Interactive comment on “Detection of Land Subsidence due to Excessive Groundwater Use Varying with Different Land Cover Types in Quetta valley, Pakistan Using ESA-Sentinel Satellite Data” by Waqas Ahmad et al.

Received and published: 23 September 2017

Referee#1

Figure S-1. InSAR subsidence (y) versus GPS subsidence (x)

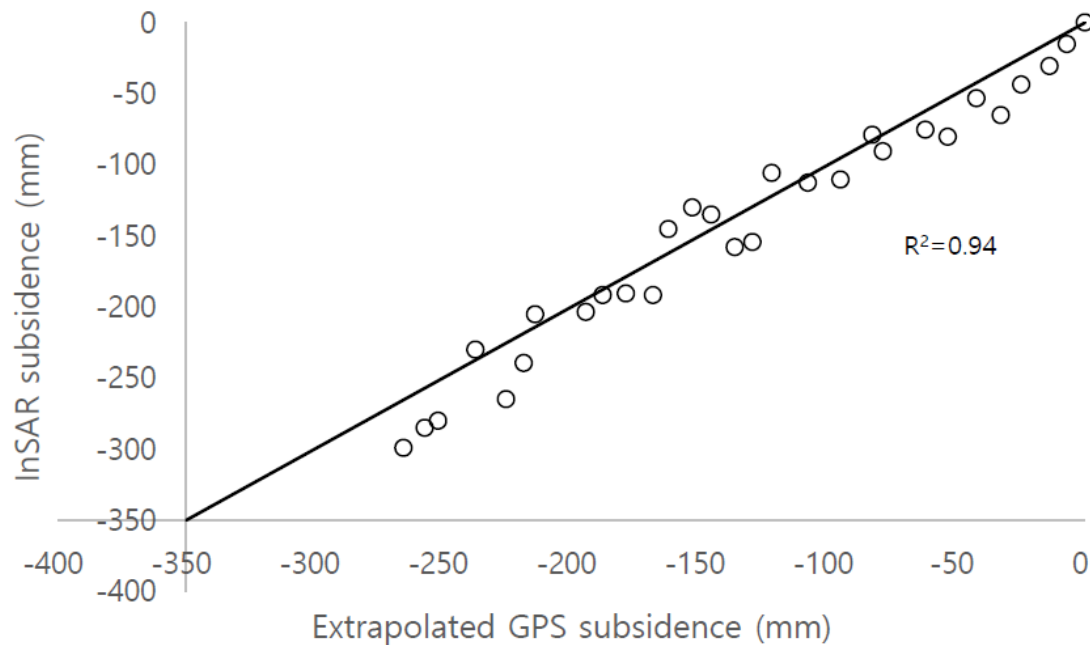
1. Your comment: As InSAR method has been widely and maturely applied in land subsidence monitoring and high precision time-series can be easily achieved for different regions. Numerous publications show good performance of this kind of application. For this specific test study, the precision of InSAR results is not high enough to show the spatial distribution and temporal evolution characteristics, as compared with GPS in Figure 9.

Our response: As you indicated, our InSAR subsidence does not precisely match the GPS-based measurement as shown in Figure 9. We found that this issue is primarily caused because our InSAR subsidence shown in Figure 9 represents the average of all subsidence pixels classified as a given land cover while the GPS-based measurement represents the subsidence at a given point location. Figure S-1 compares the subsidence trend based on the GPS measurement and our InSAR subsidence at the pixel including the GPS point. The plot shows the improved match with the R^2 value of 0.94. 2. Your comment: The quantitative correlation between surface subsidence and the underground water fluctuation is missed, i.e. the well data should be involved to show the inner correlation between land subsidence and the ground water changes.

Figure S-4. Atmospheric effects and its application to the correction of InSAR land subsidence

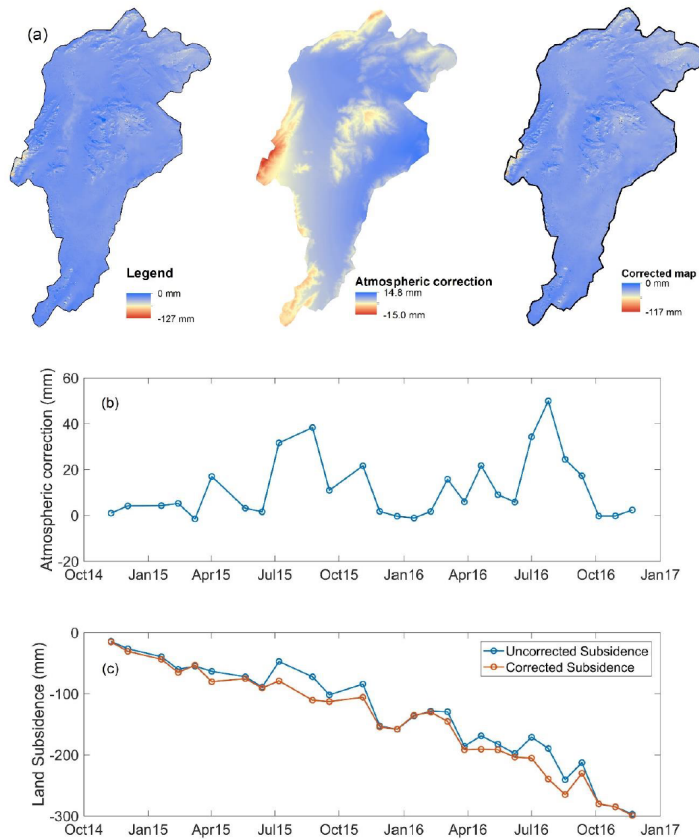
3. Your comment: Some detailed techniques such as atmospheric effect, noise filter and external DEM (SRTM 3 arc-sec. rather than 1 arc- sec) are lack or not updated, which makes the InSAR results be not good.

Our Response: We already applied the Goldstein filter (line 6, page 4) and the external DEM (3 arc sec) (line 5, page 4) to improve the accuracy of the InSAR subsidence values, but we did not perform the correction for atmospheric effect. Following your suggestion, we performed the correction for the atmospheric effect. We used the atmospheric phase delay model of Baby et al., (1988) in combination with climatic data ERA Interim from the European Center for Medium-Range Weather Forecasts (ECMWF) to generate atmospheric delay differential maps in accordance with the SAR interferograms. Figure 4(a) shows the two contrasting cases of subsidence before and after the atmospheric effect across the study area, the differential maps are for the date of 2014-10-16 and 2014-11-09. Figure S-4(b) shows the amount of atmospheric correction (mm) at the GPS location of Figure S-2. From the mild to severe cases, the subsidence was corrected by -0.59 mm through 49.95 mm at the GPS point. The effect was more pronounced during the summer months as compared to the winter months. After the correction, the time series of land subsidence showed less fluctuation as shown in Figure S-4(c).

Figure S-6. Sentinel 2 RGB color composite image of July 4, 2016 used for the classification of land cover classes

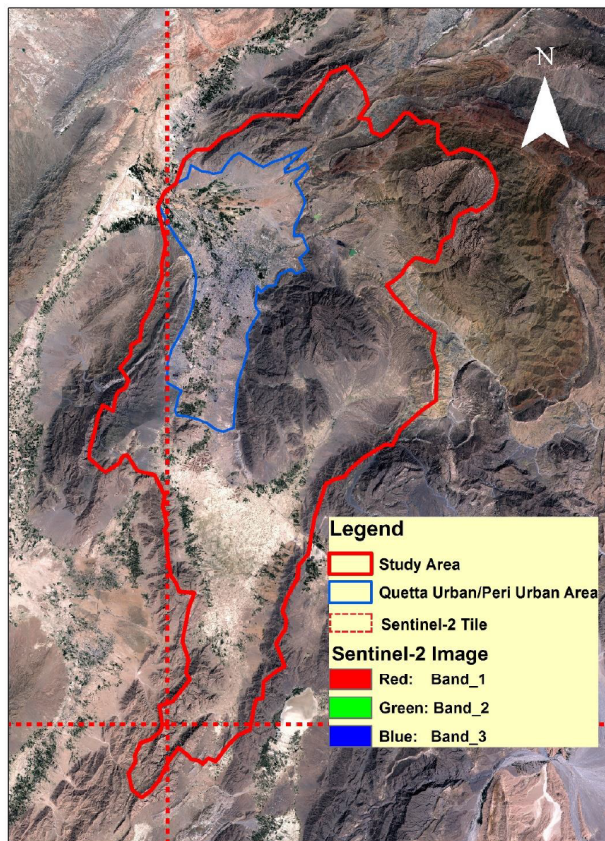
8. Your comment: The acquisition time of the ESA Sentinel-2 data used to the detection of land cover classes should be presented. The original image should be mapped. The precision of the detection of land cover types also need to presented.

Our Response: The Sentinel-2 original image along with the acquisition date used in the detection of land cover classes is presented in Figure S-6. We assessed the accuracy of land cover classification using the widely used approach of error matrix (Response to comment #1 of anonymous referee #2 i.e. Table S-1 page 6 line 12-22) and the method of Kappa coefficient (Gomez & Montero, 2011). The overall accuracy of the land cover classification was found to be 81 % with Kappa coefficient of 0.76.
